Preliminary Consultation
MONTGOMERY COUNTY HISTORIC PRESERVATION COMMISSION
STAFF REPORT

Address:	6700 Needwood Road, Derwood	Meeting Date:	6/12/2024
Resource:	Master Plan Site #22/35 Needwood Mansion	Report Date:	6/5/2024 <u>6/7/2024</u>
Applicant:	Montgomery Parks (Eileen Emmett, Agent)	Public Notice:	5/29/2024
Review:	Preliminary Consultation	Tax Credit:	N/A
Permit Number:	1071486	Staff:	Chris Berger
Proposal:	Building alterations for ADA accessibility improvements, tree removals, and other alterations.

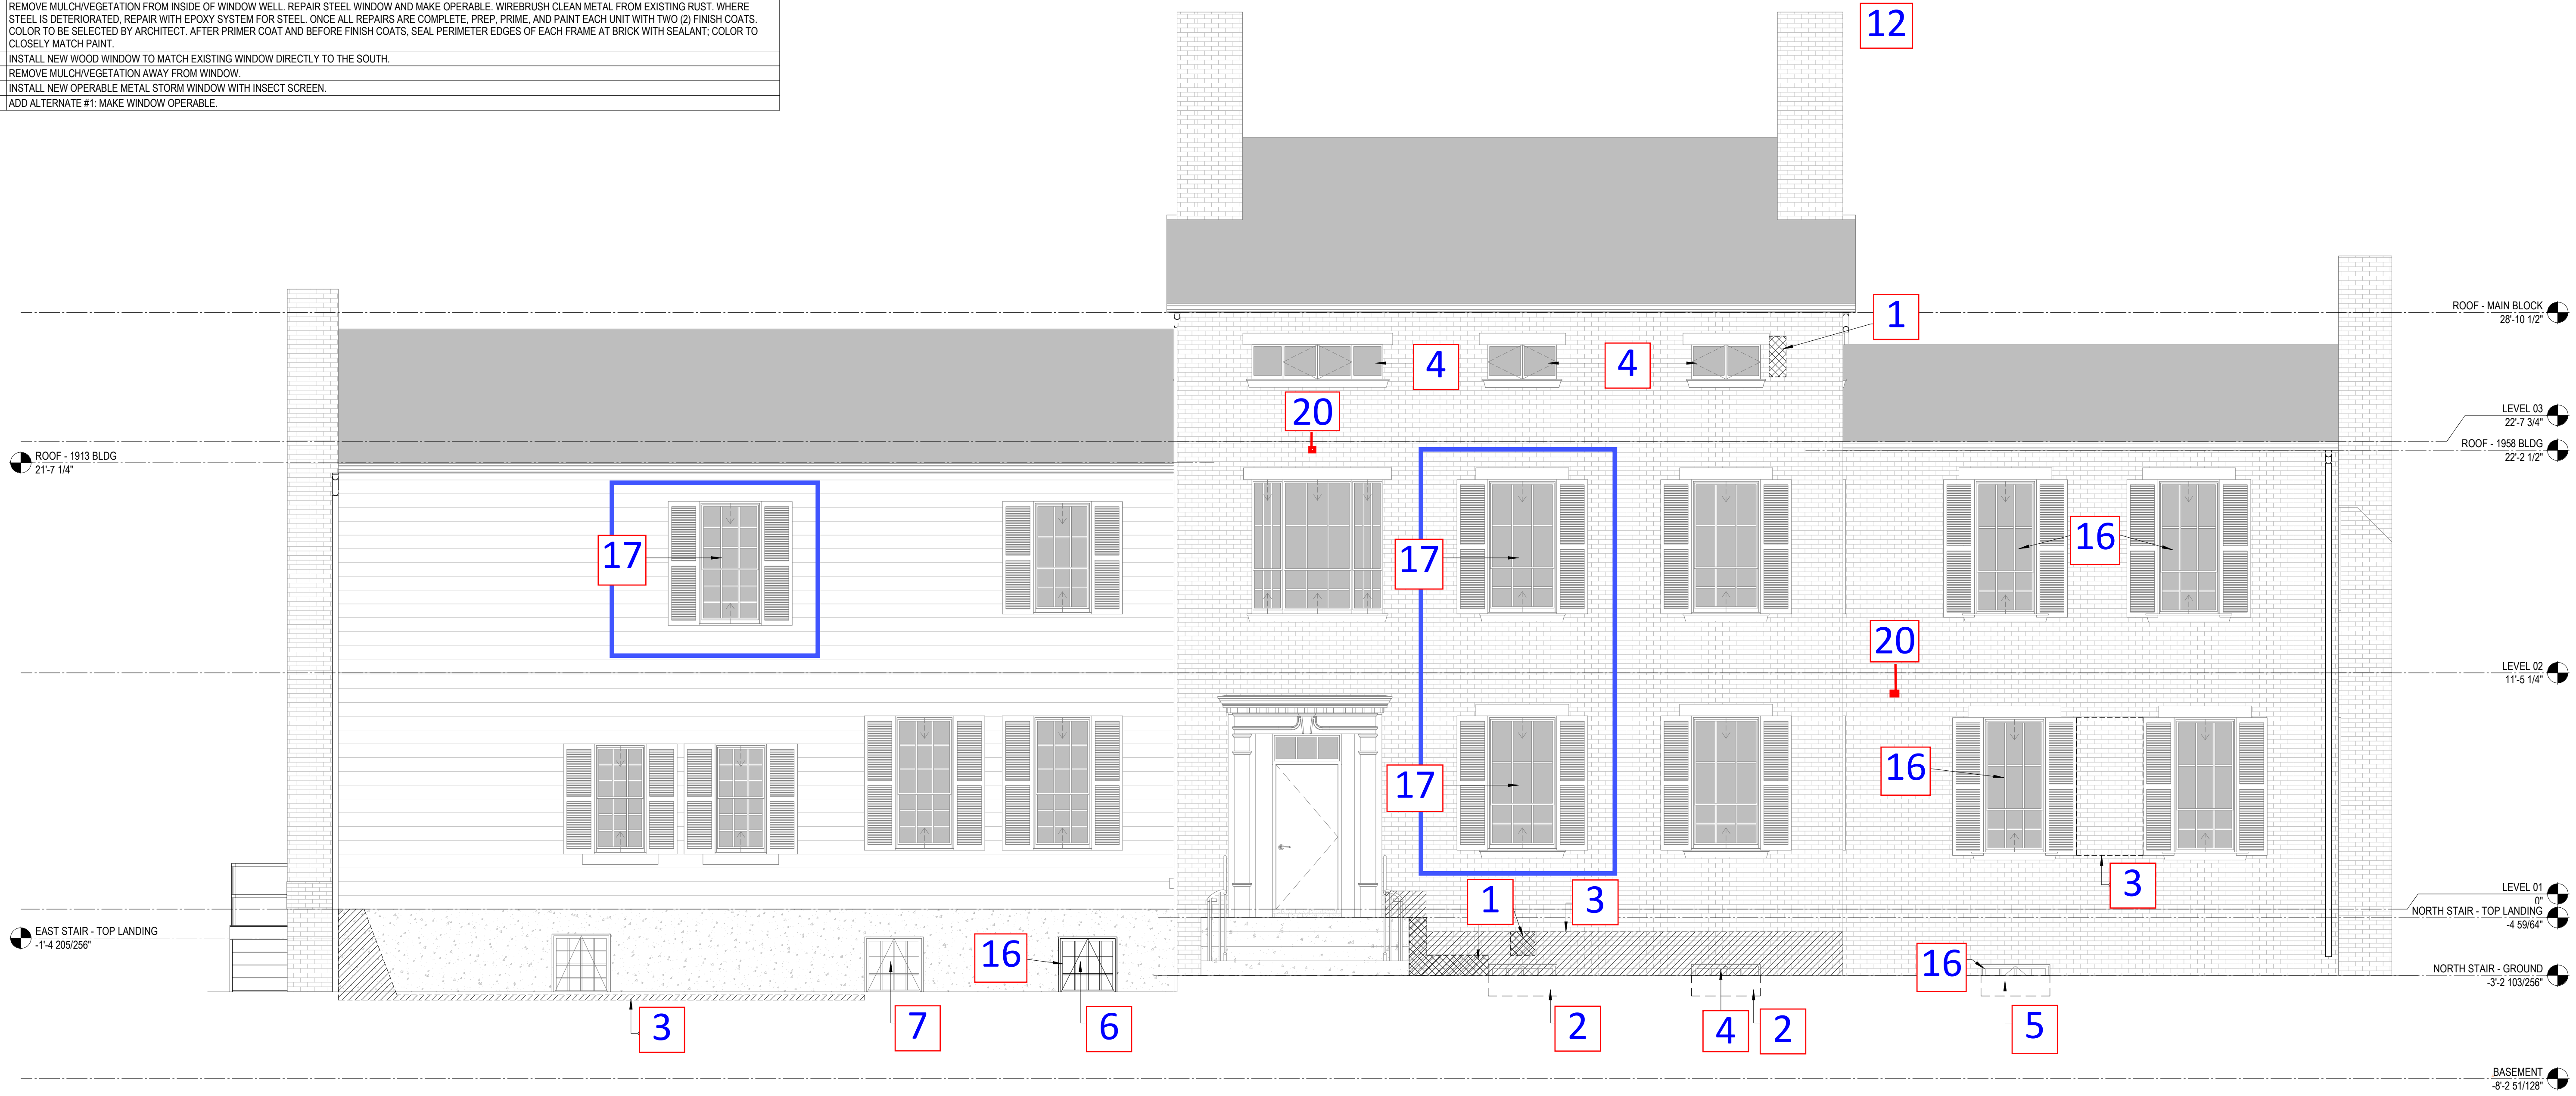
Staff supports the installation of new wood window at the basement on the front elevation (Work Item 6 on **Figure 8**) and finds the work meets both Chapter 24A-8(b) and the applicable *Standards*. The replacement window is to match the others wood windows at the basement found on the elevation, so it will be compatible to the historic site.

Staff supports the installation of lead-coated copper caps on each of the six chimneys (Work Item 12 on **Figures 8-11**) and finds the work meets both Chapter 24A-8(b) and the applicable *Standards*. According to the applicant, the chimneys are not capped, so the caps are necessary to prevent moisture and wildlife from gaining entry into the chimney stacks. Staff seeks a detail or specification for the proposed caps.

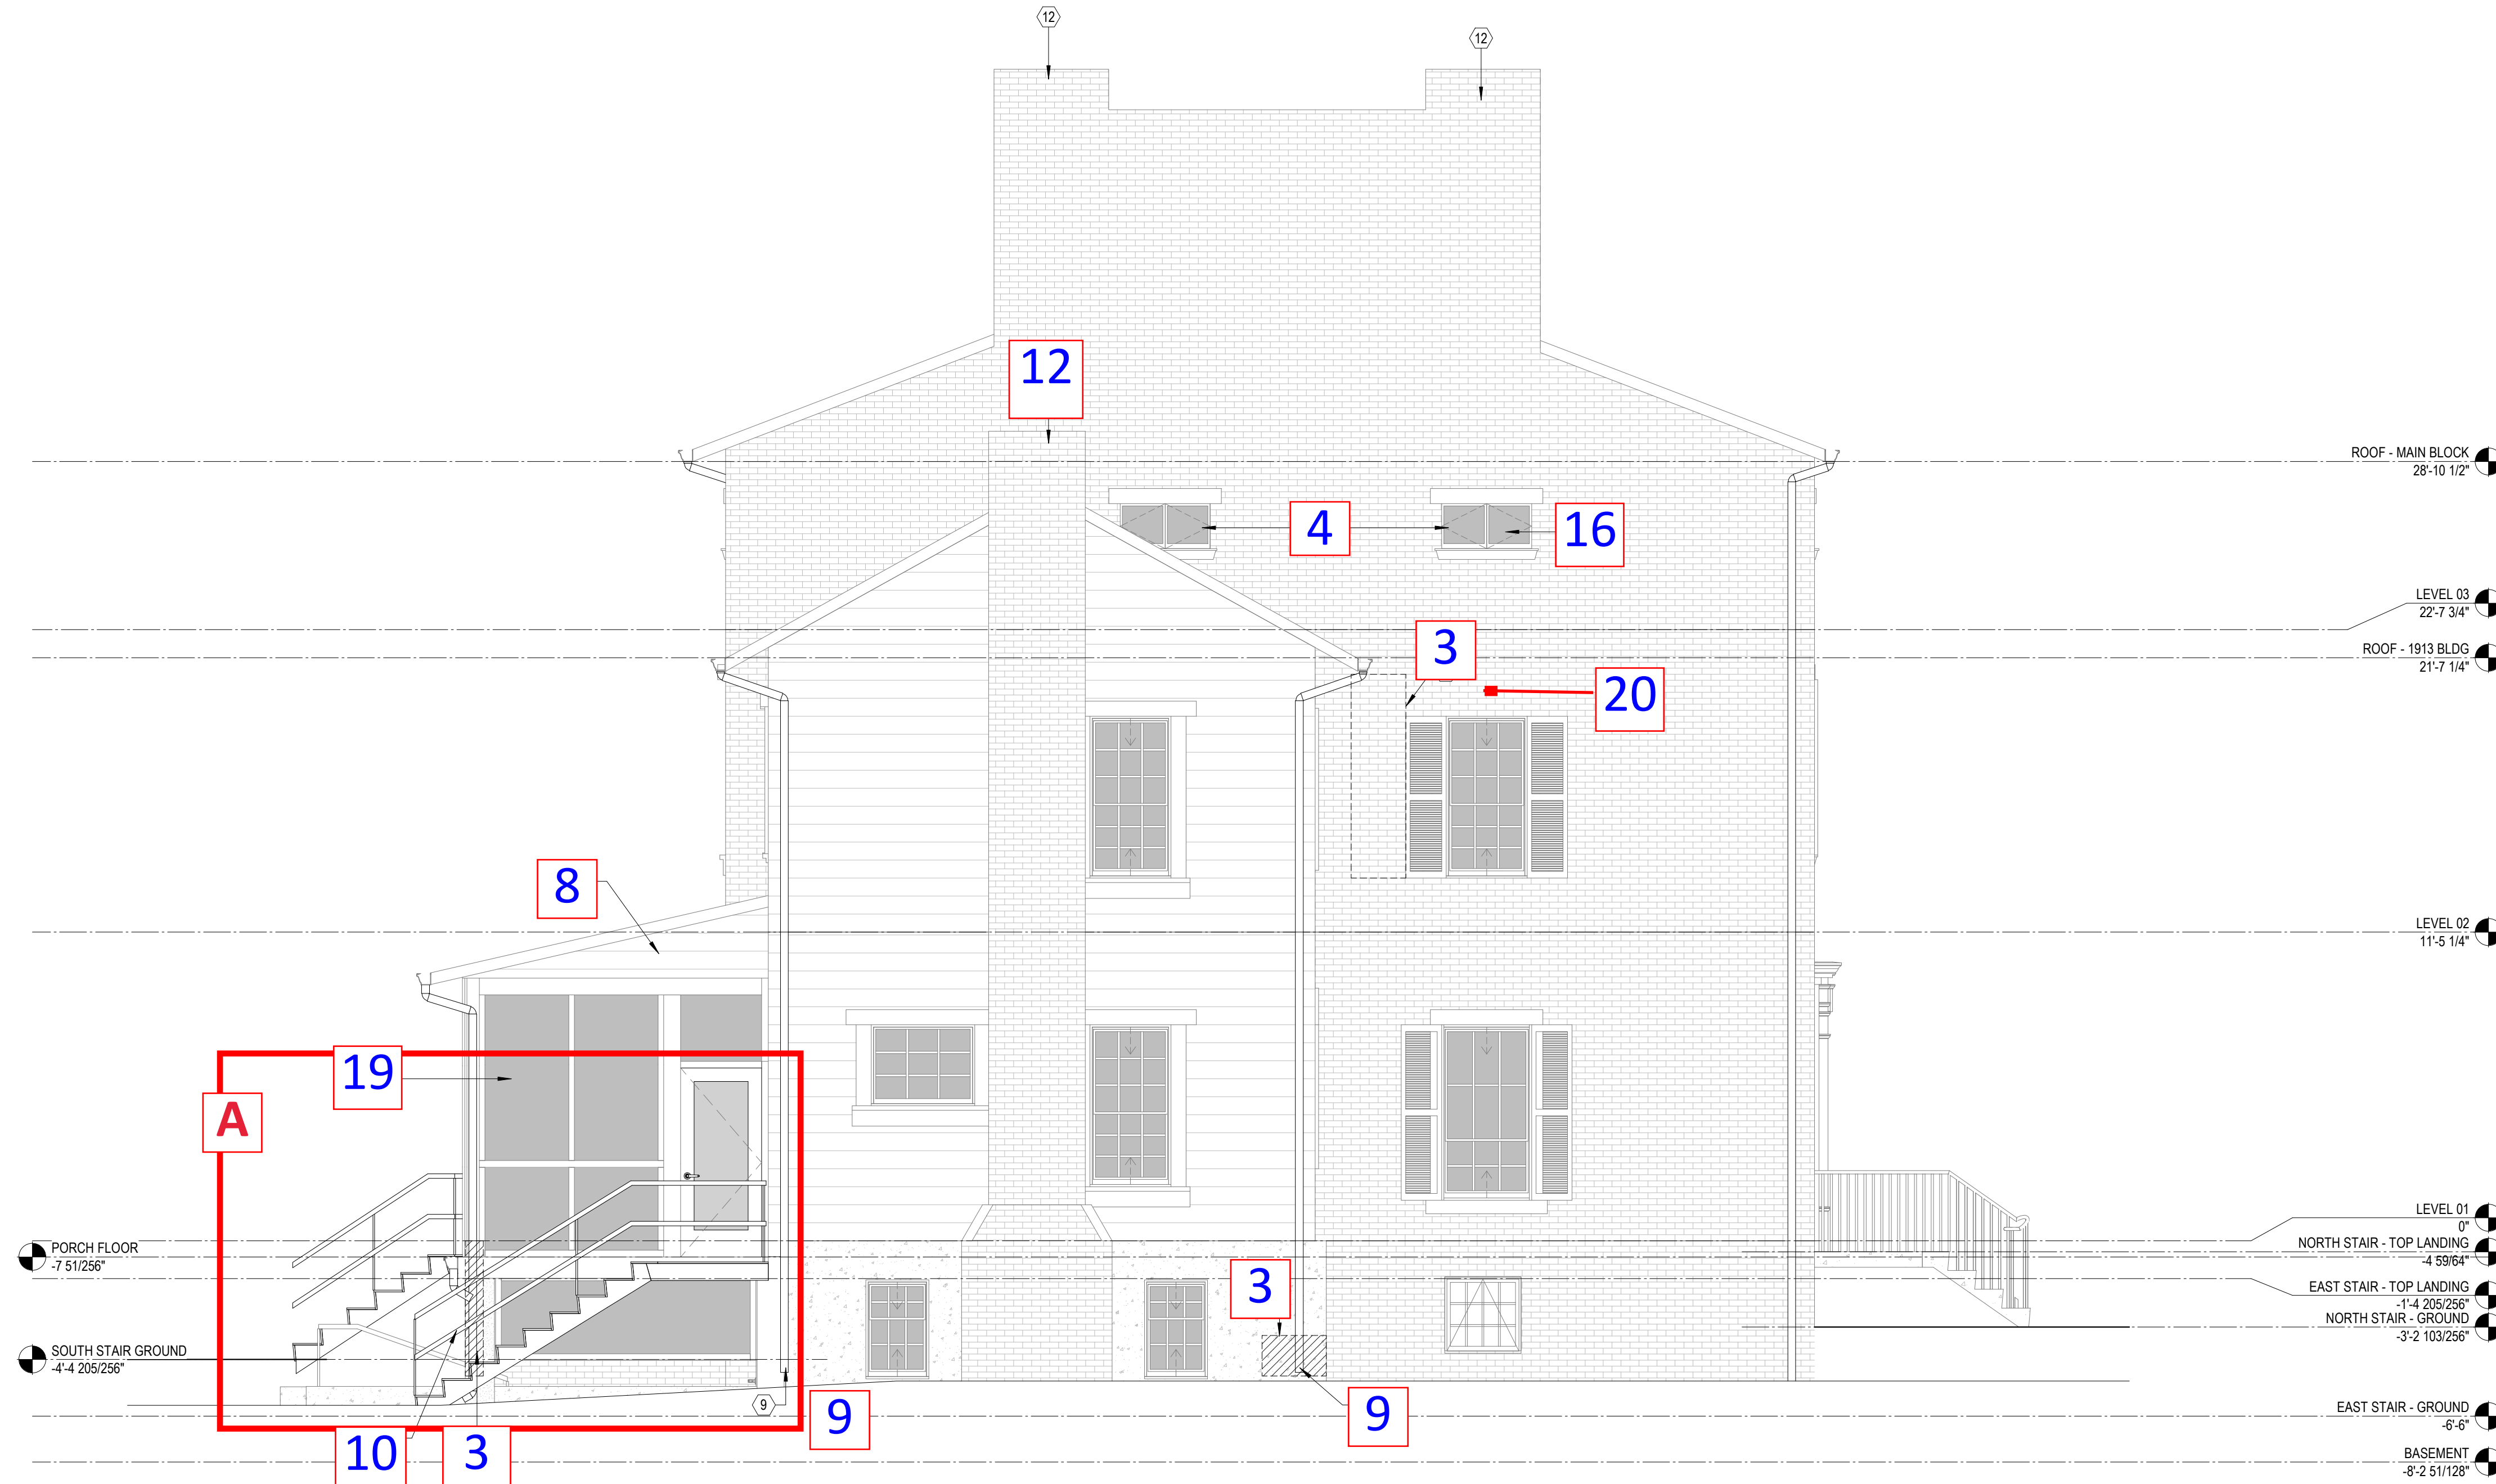
Staff supports the installation of downspout extensions and splash blocks on the left-side elevation (Work Items 9 and 10 on **Figure 9**) and finds the work meets both Chapter 24A-8(b) and the applicable *Standards*. The elements are necessary to move water away from the foundation to help protect the historic site from water damage. Staff seeks specifications for both features.

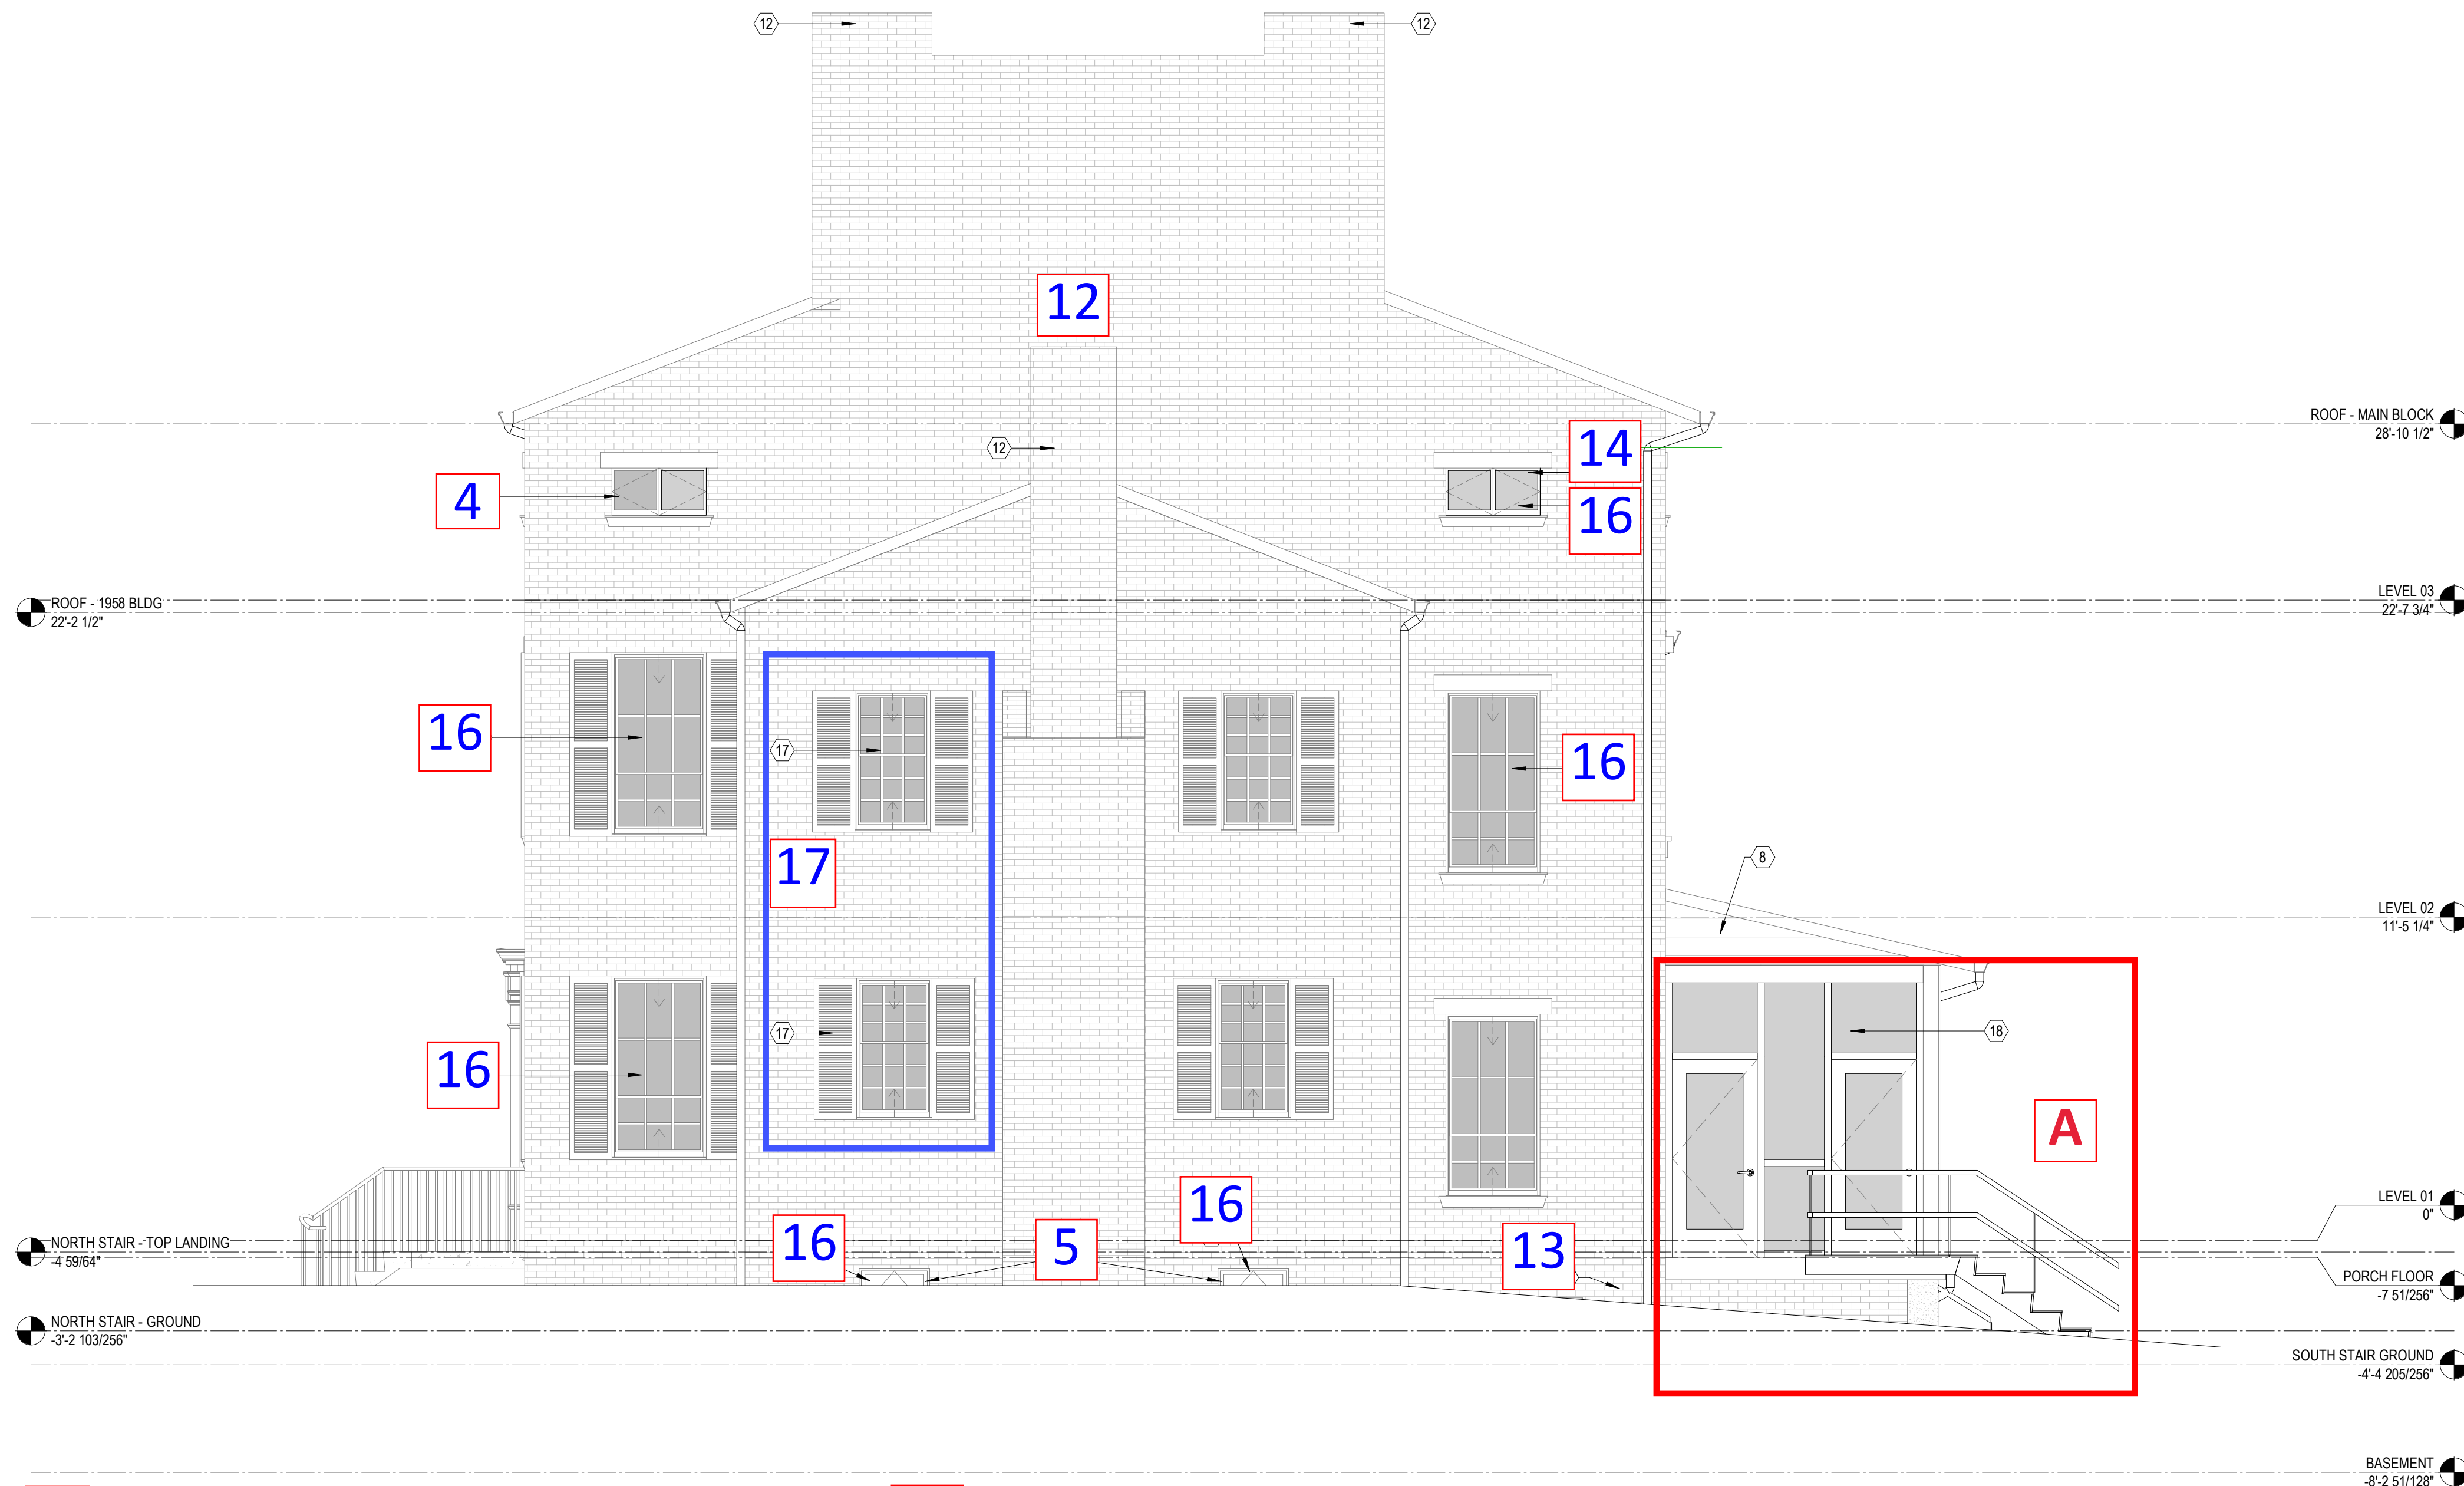
Staff supports installation of the wood window on the third floor on the right-side elevation where the window is missing (Work Item 14 on **Figure 11**) and finds the work meets both Chapter 24A-8(b) and the applicable *Standards*. The replacement window will match the design of the existing third floor wood windows, so it will be compatible with the historic site.

Staff supports alterations to the screen porch wall on the ~~west~~ right-side elevation to accommodate the ADA improvements (Work Item 18 on **Figure 11**) and finds the work meets both Chapter 24A-8(b) and the applicable *Standards*. The porch is a later alteration to the building, added in the 20th century, and is located on the rear of the building. The modification is necessary to accommodate the ADA accessibility improvements. According to the applicant, as much of the existing material as possible will be salvaged to be reused in the reconstruction of the wall.
